## ON-SITE SEWAGE DISPOSAL SYSTEM HOWARD COUNTY HEALTH DEPARTMENT BUREAU OF ENVIRONMENTAL HEALTH

SUBDIVISION: Linden Chapel Hills LOT NUMBER: 24

ADDRESS: 13612 Voland Court PROPERTY OWNER: \_\_\_\_\_

SEWAGE DISPOSAL SYSTEM

PERMIT CARD No. 71-1000

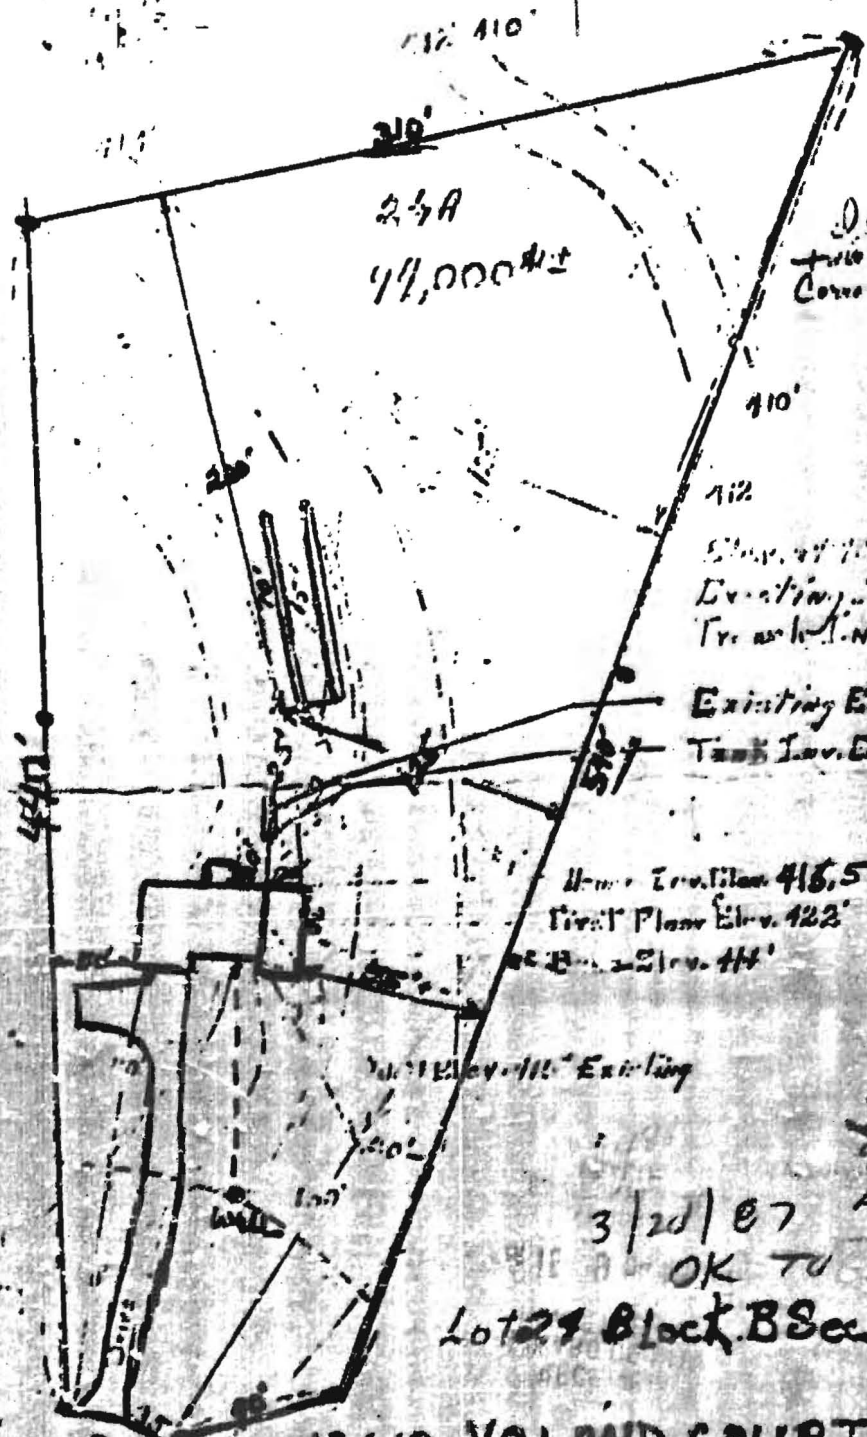
7/24/77 Site location OK. Treches OK. To fill up 5' stone & permit card no. 71-1000  
 8/5/77 48 1' 0" = 680 sq ft required 731 sq ft Replace corrugated  
 unapproved plastic pipe with approved type of pipe. Give  
 approved pipe with 2" of stone & call for inspection R. H. H. on  
 15 Aug 77 (1) pipe is of exposed construction  
 (2) stone is OK

DATE SYSTEM APPROVED 19 Aug 77 INSPECTOR L. Mansfield
